Modification IF Preamplifier (IPA) version 02

Modification A

Artemis MK5 Engineering Note EN5-8A (This Engineering Note replaces Engineering Note EN5-8)

Fig. 1

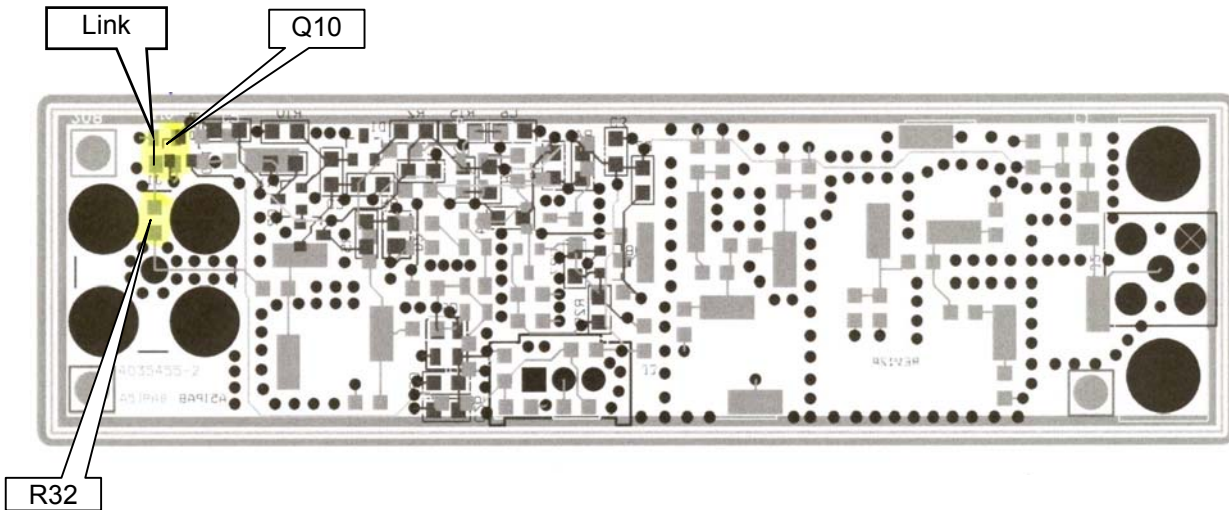
- Remove the two boards from the IPA unit. **Keep boards and mixers together!**
- Remove transistor Q10 (see figure 1 overleaf to locate Q10) .
- Remove resistor R32.
- Solder an inductor of 4.7 uH (Epcos, 90 mA, Rs 3.8 Ω) in the position of R32.
- Solder a link between the two most left points where transistor Q10 was positioned, so that one side of the inductor is connected to ground.
